DOCUMENT 00 90 00
ADDENDUM

ADDENDUM NO. [2] **Date: September 23, 2021**

RE: LA FARGE SCHOOL DISTRICT
ADDITION AND RENOVATION
301 W. ADAMS STREET
LA FARGE, WI 54639
HSR Project 19041-1

FROM: HSR Associates, Inc
100 Milwaukee Street
La Crosse, WI 54603
(608) 784-1830

Sheet Title: LOWER LEVEL - SEGMENT A & B

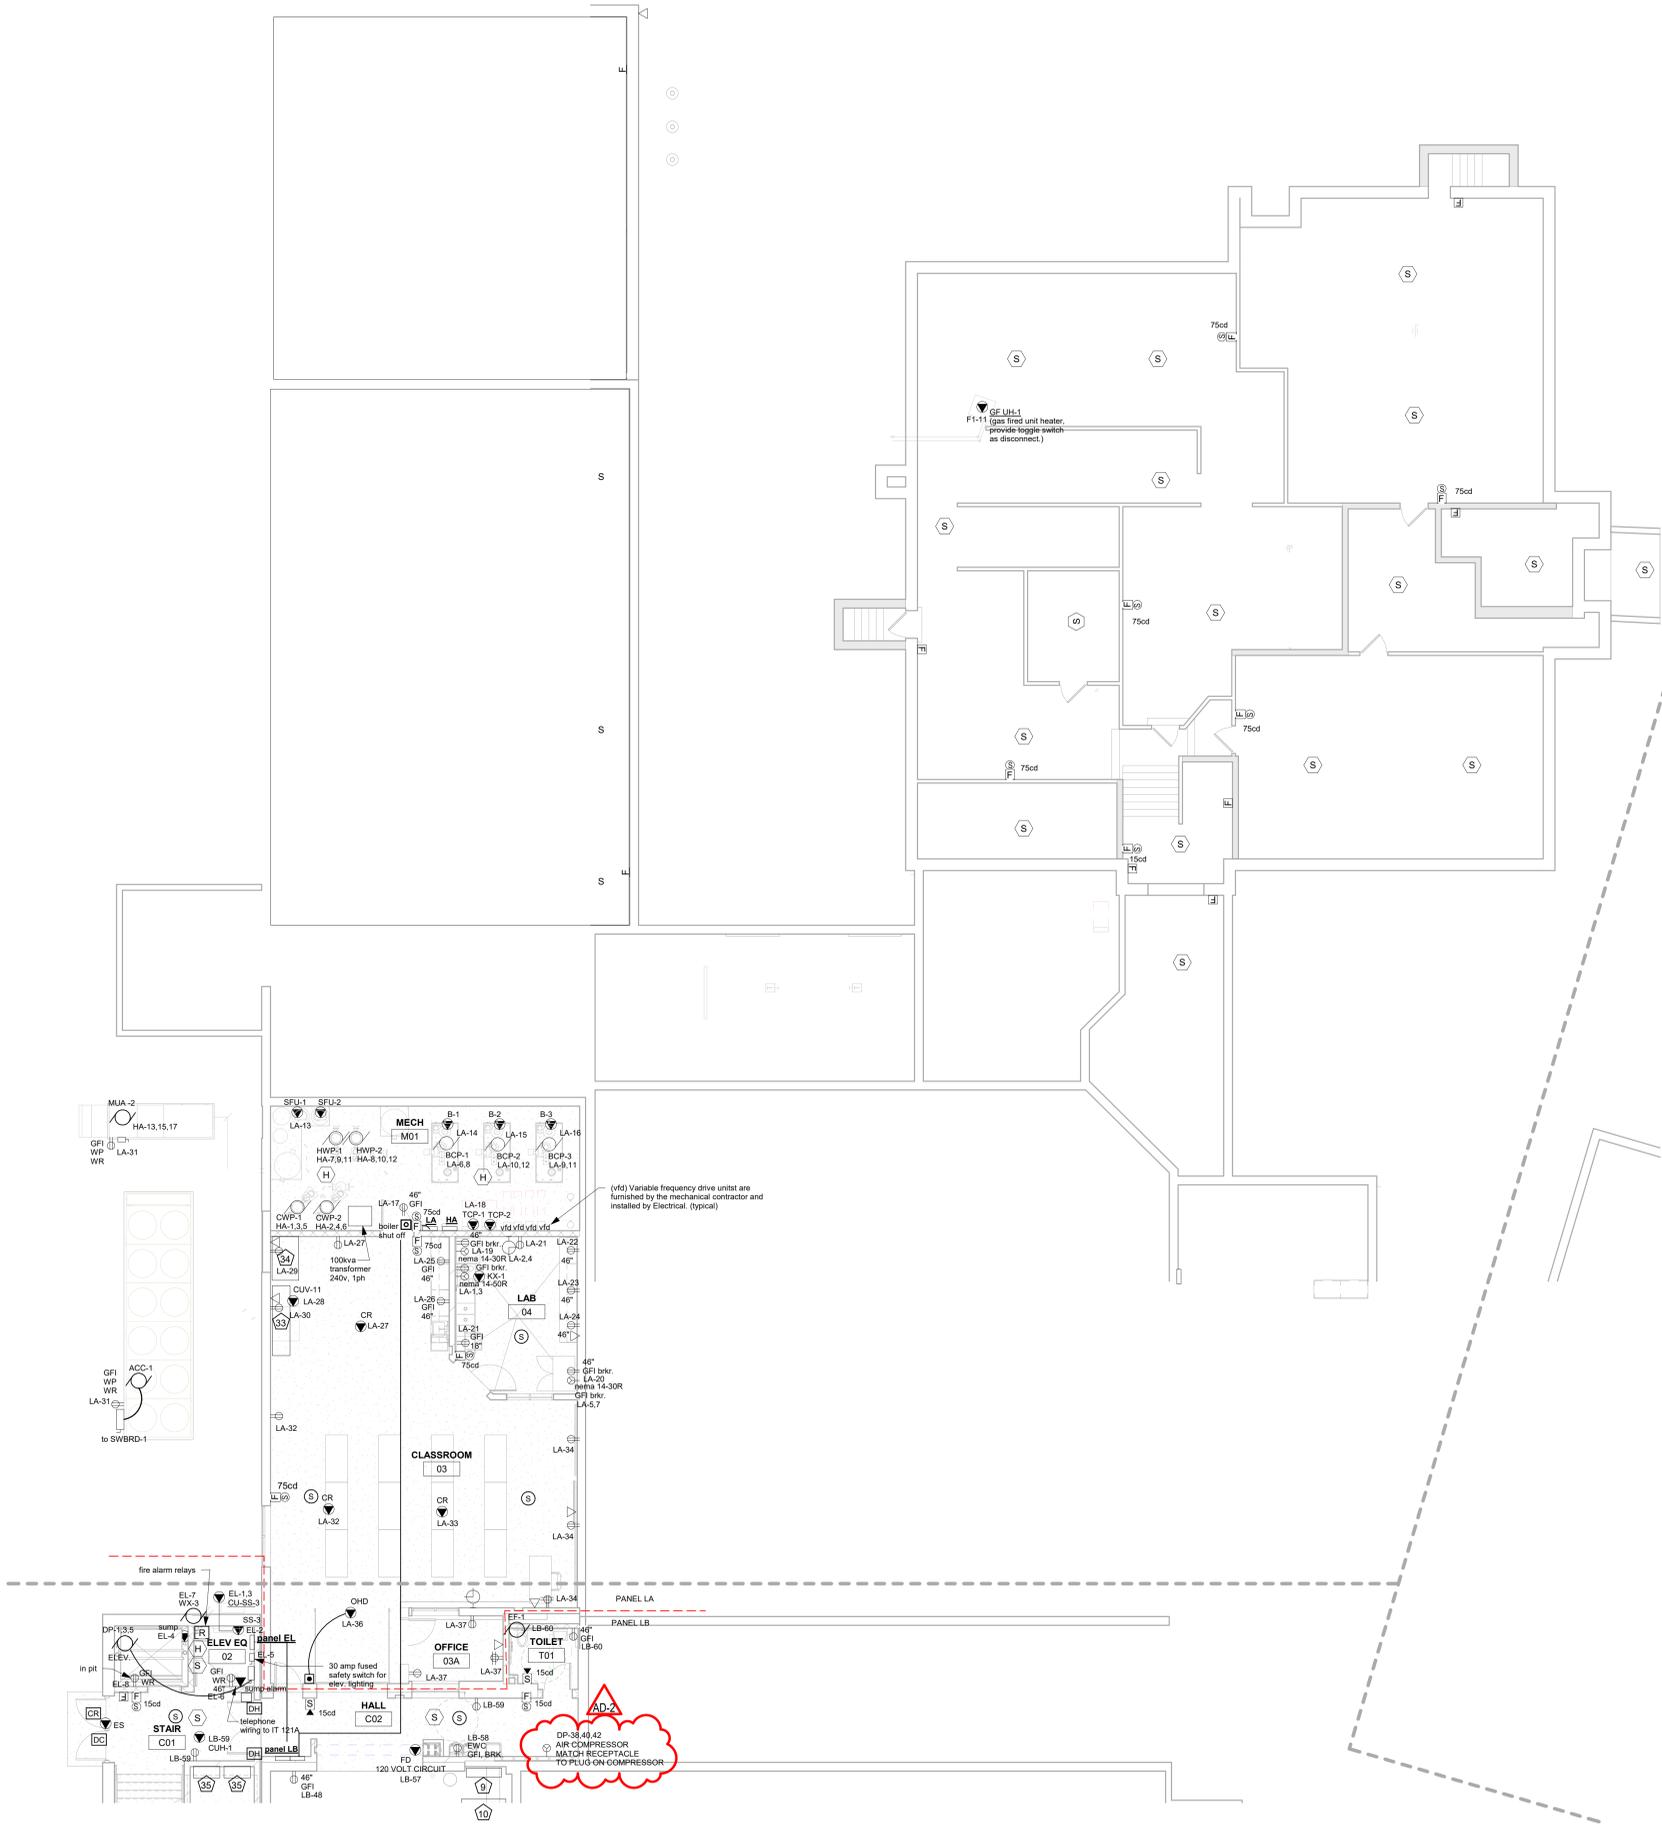
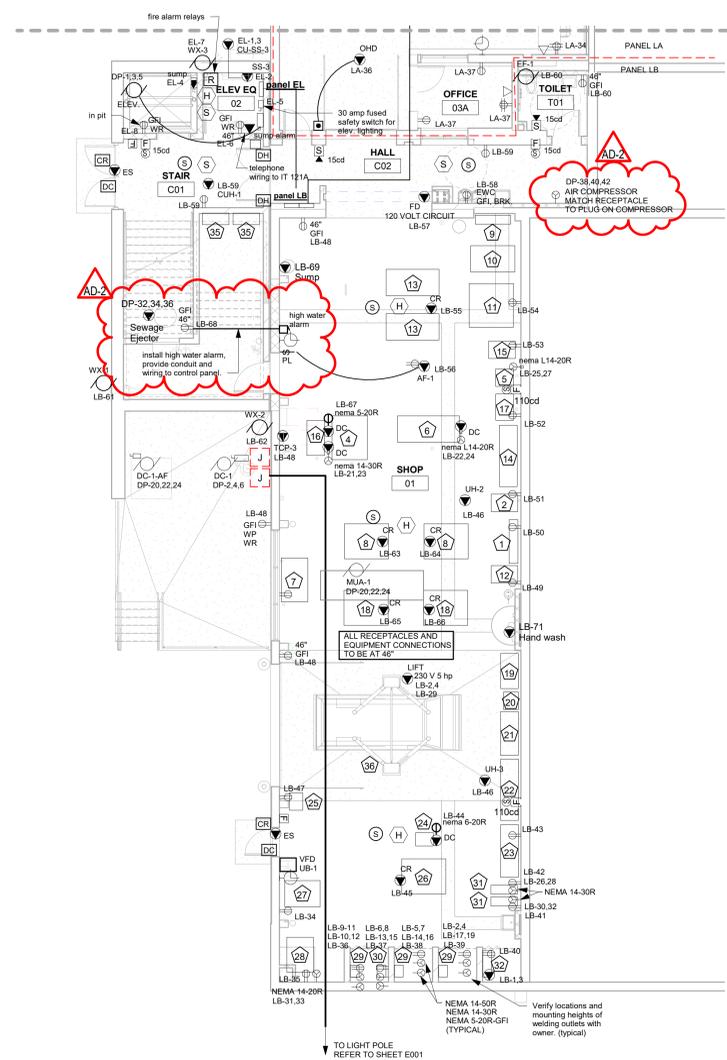
- a. Added areas of demolition.
24. Sheet E093 – FIRST FLOOR ELEC. DEMO PLAN – SEG. C 30 x 42 attached hereto
 - a. Added areas of demolition.
25. Sheet E100- LOWER LEVEL – SEGMENT A & B 30 x 42 attached hereto

- a. Provided electrical connections to additional equipment.
26. Sheet E101- FIRST FLOOR POWER PLAN – SEG A 30 x 42 attached hereto
 - a. Add electrical connections at ADA lift.

1 FIRST FLOOR POWER PLAN -SEG B
 1/8" = 1'-0"

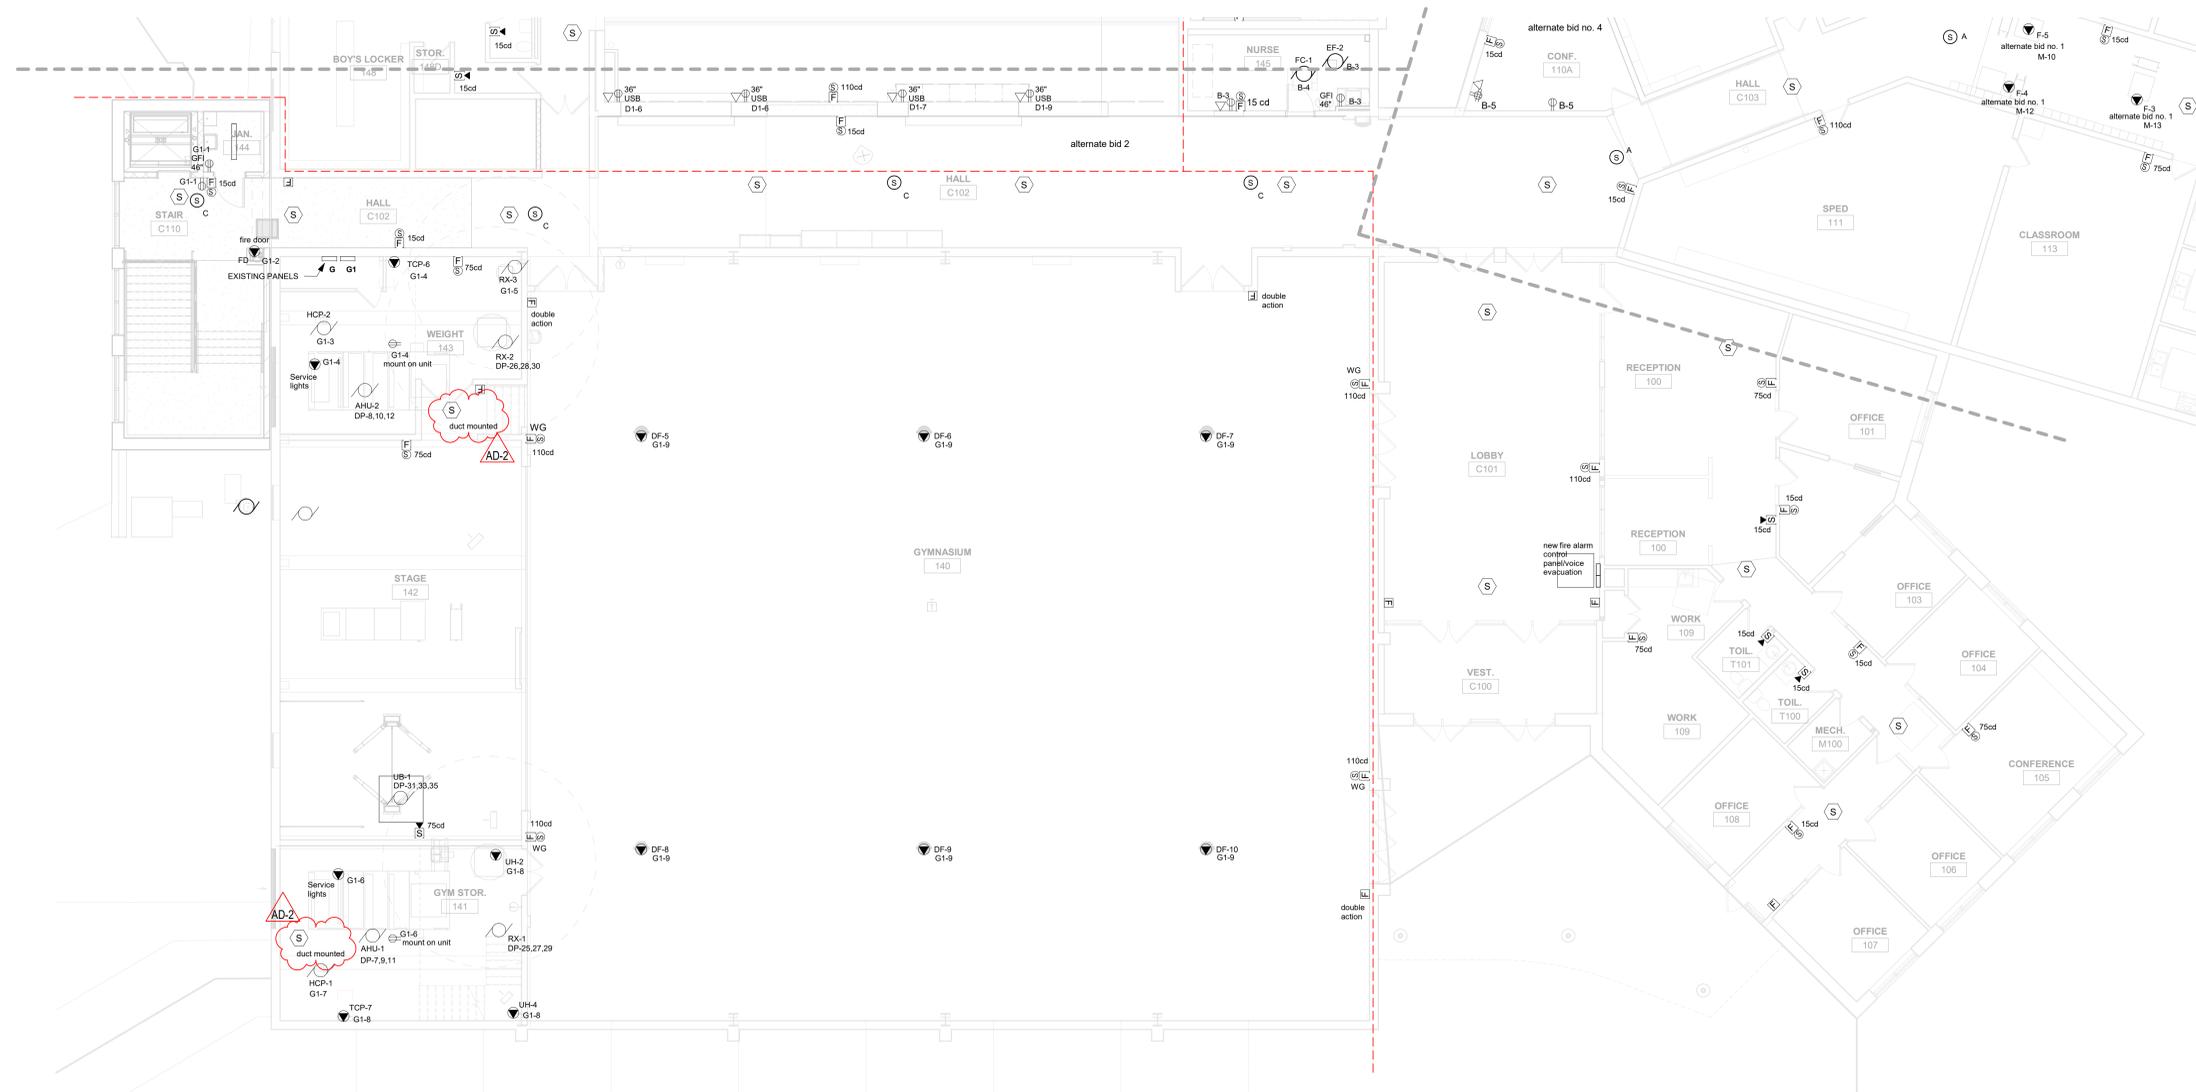
- b. Added duct mounted smoke detectors.
27. Sheet E102- FIRST FLOOR POWER PLAN – SEG B 30 x 42 attached hereto
 - a. Added duct mounted smoke detectors.

1 SECOND FLOOR POWER PLAN - SEG A

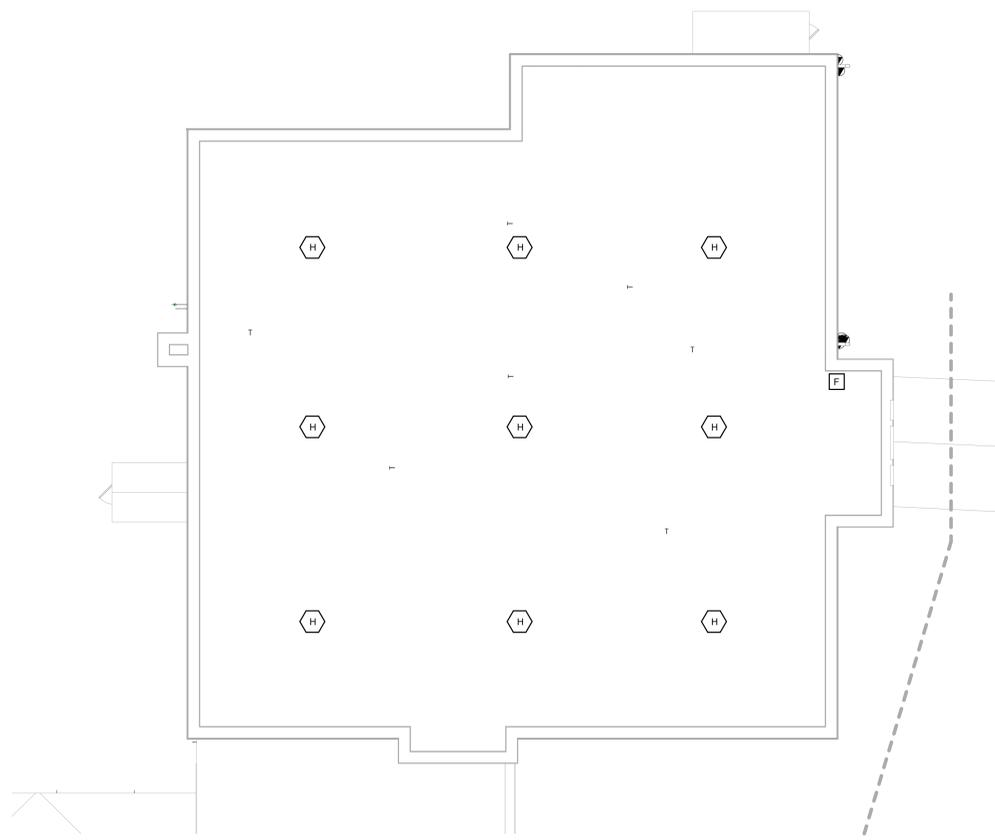
- a. Add electrical connections at ADA lift
30. Sheet E201 –LOWER LEVEL LIGHTING PLAN – SEG A & B 30 x 42 attached hereto
 - a. Added light fixtures in welding booths in shop 01.
